EPSC PLAN NARRATIVE

EPSC NARRATIVE BRIDGE 52		
PROJECT NAME:	WINHALL	SHEET NO. 1
PROJECT NO:	STP CULV (31)	
DRAWN BY:	CHK'D BY:	OF 8
CE	04/16/2015

From: Jacqueline Dagesse [<mailto:jdagesse@eivtech.com>]
Sent: Wednesday, April 29, 2015 7:16 PM
To: Lemaire, Ron
Cc: Farley, William; Mackintosh, Mark
Subject: Winhall STP CULV(31) EPSC Plan Review

We reviewed the Winhall STP CULV (31) EPSC Plan, and have the following questions / comments:

FILTER BAG

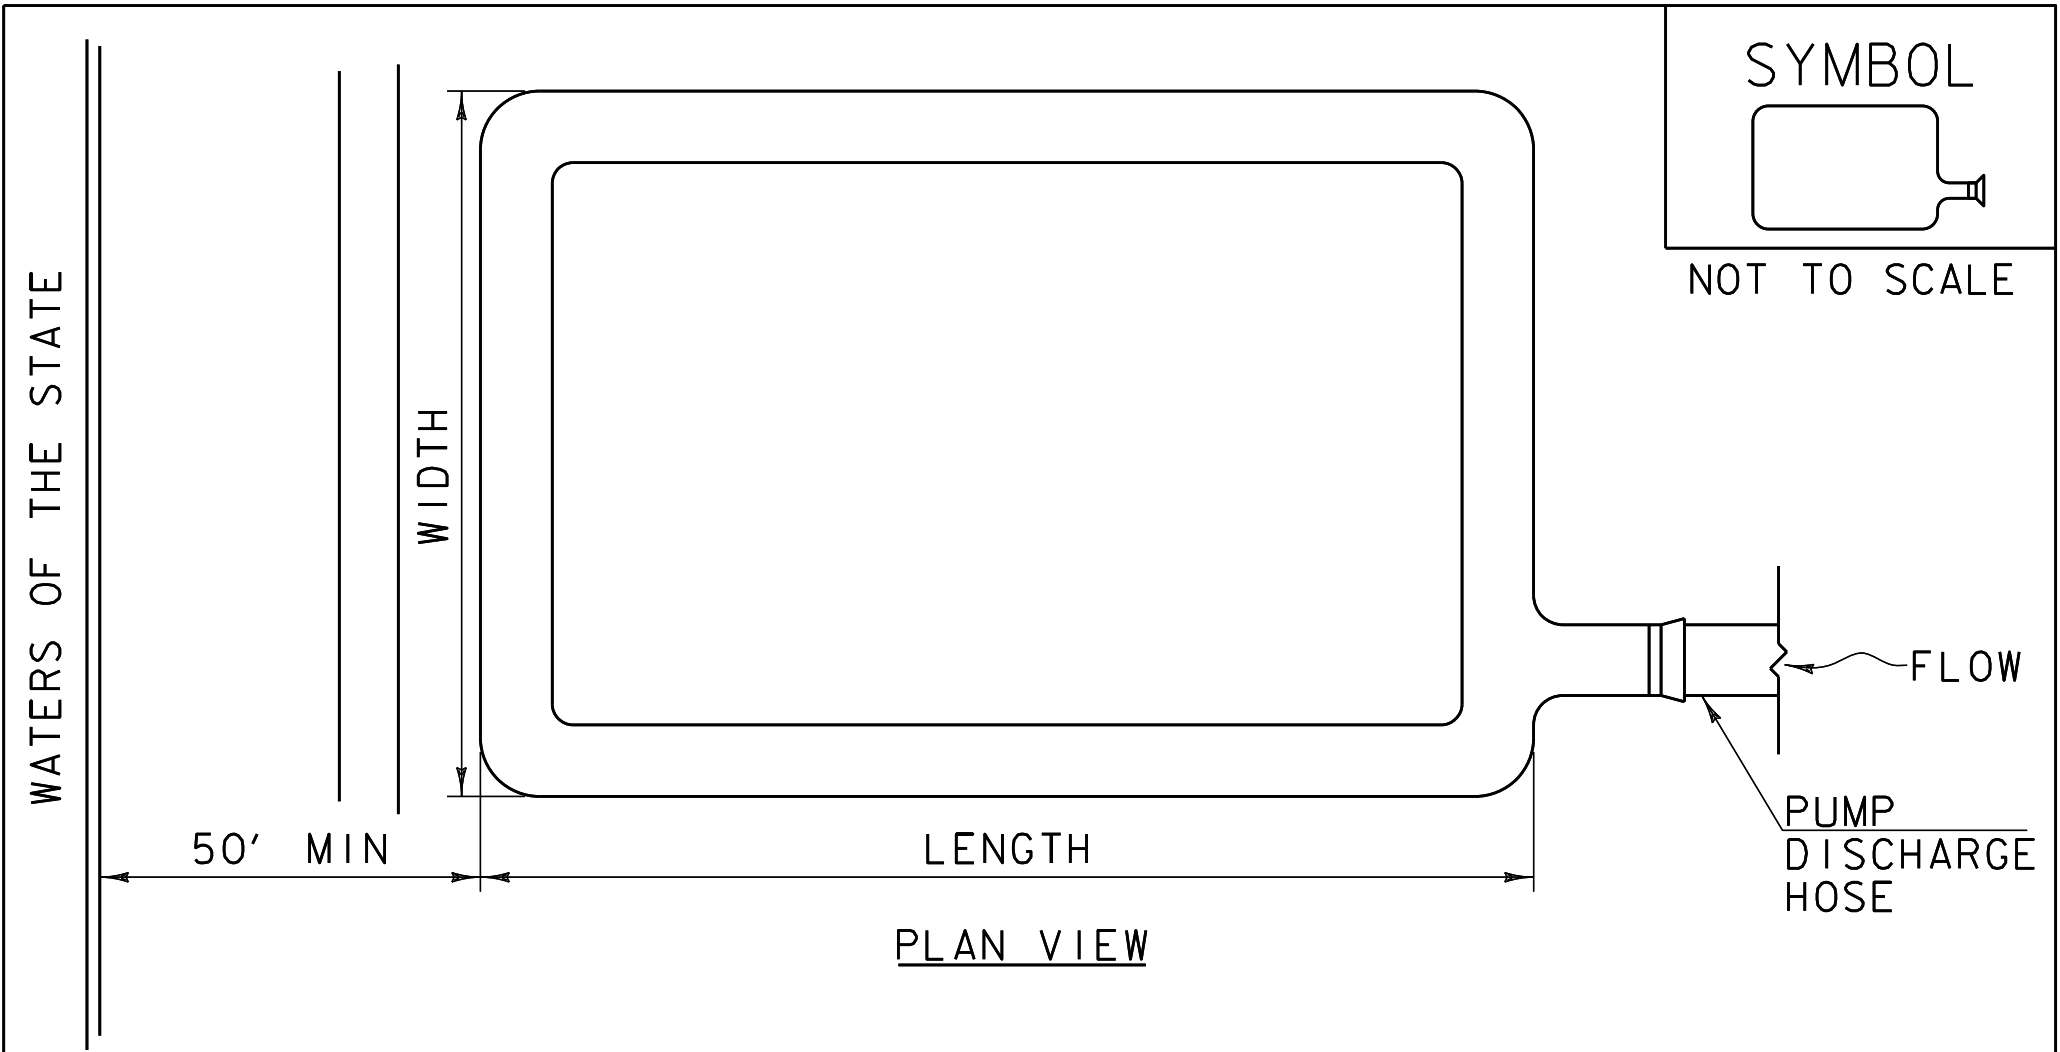
- It appears that some detail was added to the construction sequence within the existing EPSC narrative. However, we also need to have Renaud Brothers describe EPSC measures which would be used for those phases in more detail.
- In the EPSC narrative they mention that they will need to dewater. I did not see any dewatering locations called out on the plansheets. We need to have this information included.
- The EPSC plansheets need to include resource information, stationing and a north arrow.
- Who is the OSPC? What is their contact information?
- We need to have a description on the proposed offsite activities within this submittal.
- The schedule and inspection form were not part of this submittal.
